City of Detroit
Inter-Departmental Communication

RE: Petition No. 540
Request for Conversion to Easement a Portion of Cambridge in the Block Bound
by Ohio, Cherrylawn, Seven Mile and W. Outer Dr.

NOTICE OF PROPOSED CHANGE IN PROPERTY

PETITION NO. 540
 U of D JESUIT HIGH SCHOOL
 8400 SOUTH CAMBRIDGE AVE.
 DETROIT, MICHIGAN 48221
 C/O KARL KISER, S.J.
 PHONE NO. 313 862-5400

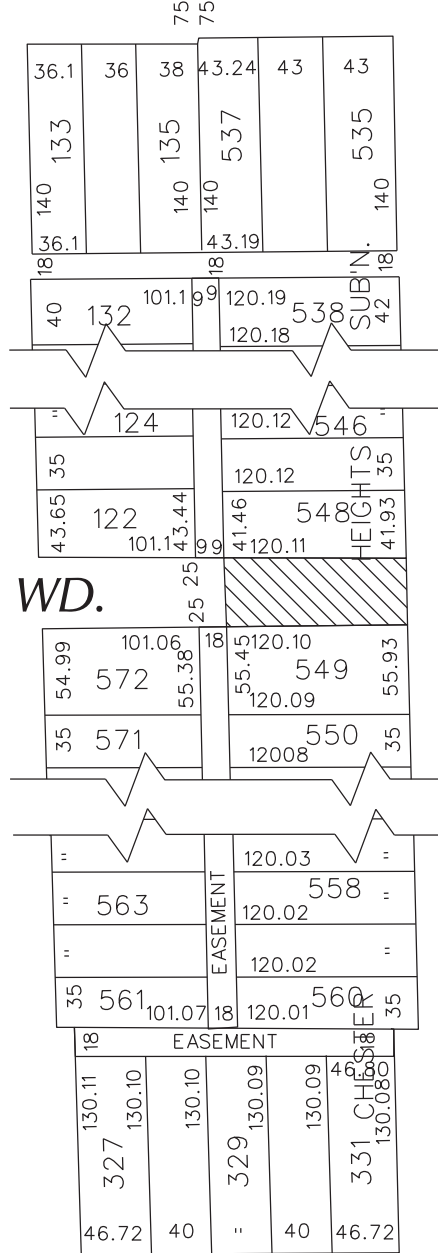
- Our records indicate that there is a sewer in Cambridge. DWSD has no objection to the conversion to easement provided that the attached Provisions for Conversion to Easement are strictly followed.

1. An easement, the full width of the existing right of way, is reserved for the Detroit Water and Sewerage Department for the purpose of installing, maintaining, repairing, removing, or replacing any sewers, water mains, fire hydrants and appurtenances, with the right of ingress and egress at any time to, and over said easement for the purpose above set forth.

Free and easy access to the sewers, water mains, fire hydrants and appurtenances within the easement is required for Detroit Water and Sewerage Department equipment, including the use of backhoes, bull dozers, cranes or pipe trucks, and other heavy construction equipment, as necessary for the alteration or repair of the sewer or water main facilities.

2. Said owners of the adjoining property, for themselves, their heirs and assigns, agree that no building or structure of any nature whatsoever, including fences, porches, patios, balconies, etc., shall be built upon or over said easement, or that no grade changes or storage of materials shall be made within said easement without prior written approval and agreement with the Detroit Water and Sewerage Department.
